What is the correct value for  $N_p$  for determining TxSNDR of test transmitter during calibration of the Interference Tolerance Test. Addresses D1.3 comments 200,446,552 and 557.

802.3dj Jan 2025 Interim Phoenix.

Mike Dudek          Marvell

Figure 93C-2—Interference tolerance test setup

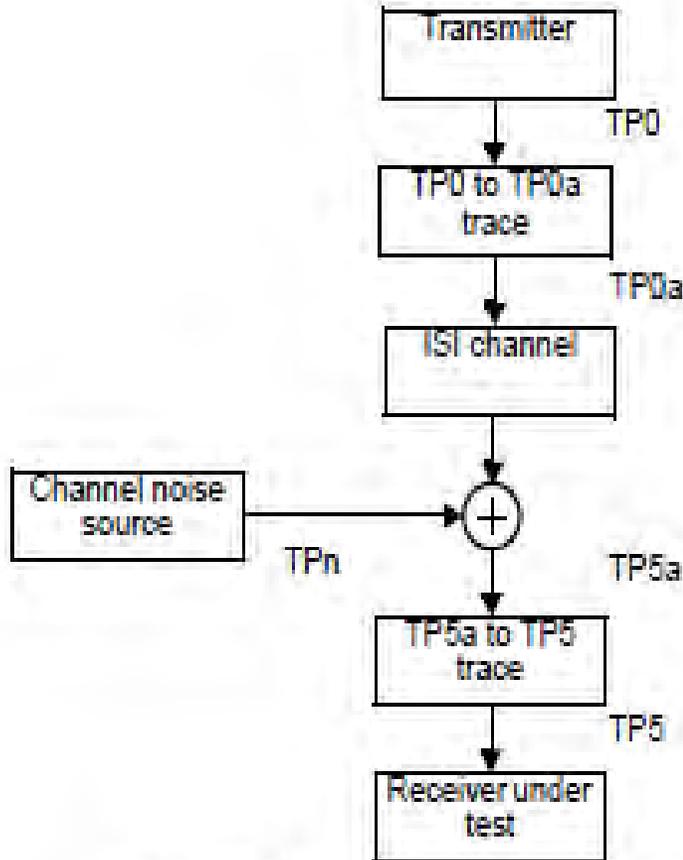
- The TP0 to TP0a trace is omitted if an instrument grade Transmitter is used.
- The Transmitter is measured at TP0a for jitter and TxSNDR and risetime
- The S parameters of the test channel (from TP0 to TP5) are measured.
- COM is calculated using the Measured Transmitter characteristics for jitter and risetime and replacing TxSNR with the measured value of TxSNDR.
- The Channel noise source amplitude is adjusted to achieve the target value of COM (3dB)
